UN Regulation No. 153 (Fuel system integrity and electric power train safety at rear-end collision)

Proposal for the 01 series of amendments to UN Regulation No. UN Regulation No. 153 (Fuel system integrity and electric power train safety at rear-end collision)

Submitted by the expert from France *

"Annex 2

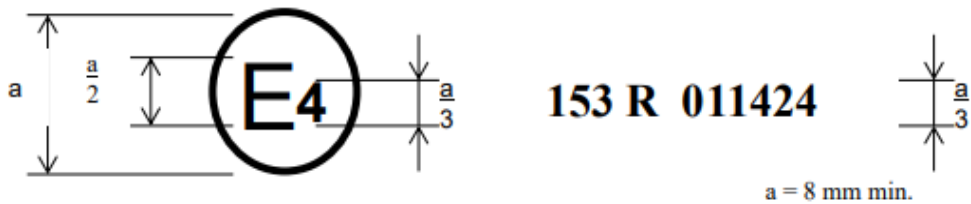
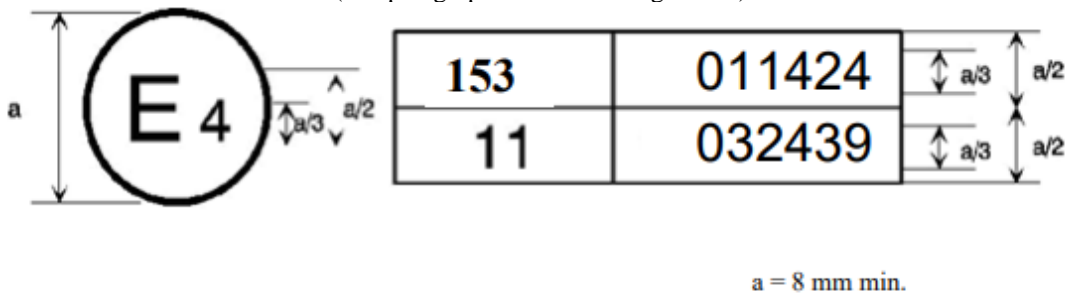
Annex 2, amend to read:

The above approval mark affixed to a vehicle shows that the vehicle type concerned has, with regard to the protection of the occupants in the event of a frontal collision, been approved in the Netherlands (E 4) pursuant to UN Regulation No. 153 under approval number 001424. The approval number indicates that the approval was granted in accordance with the requirements of UN Regulation No. 153 as amended by the 01 series of amendments.

The first two digits of the approval numbers indicate that, at the dates when the respective approvals were granted, UN Regulation No. 153 incorporated the 01 series of amendments and UN Regulation No. 11 incorporated the 03 series of amendments"

Figure 3
Jointed Test Finger

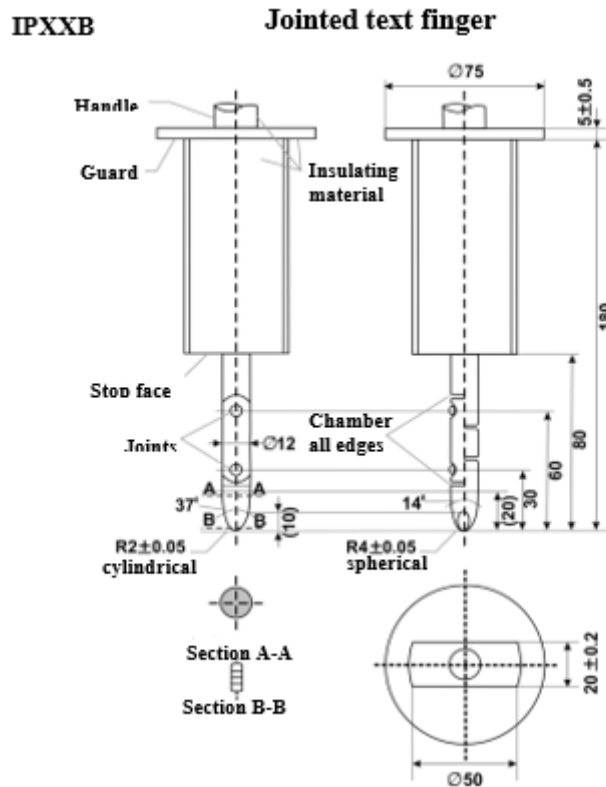
The jointed test finger described in Figure 3 shall be inserted into any gaps or openings of the physical protection with a test force of $10 \text{ N} \pm 10$ per cent for electrical safety assessment. If partial or full penetration into the physical protection by the jointed test finger occurs, the jointed test finger shall be placed in every position as specified below.

Starting from the straight position, both joints of the test finger shall be rotated progressively through an angle of up to 90° **degree** with respect to the axis of the adjoining section of the finger and shall be placed in every possible position.

- (a) \ominus on angles: $+0/-10$ seconds $0^{\circ}0'0''/0^{\circ}0'10''$;
- (b) \ominus on linear dimensions:
 - (i) **up to** ≤ 25 mm: $+0/-0.05$ mm;
 - (ii) **over** > 25 mm: ± 0.2 mm.

If necessary, a mirror or a fiberscope may be used **in order** to inspect whether the jointed test finger touches the high voltage buses.
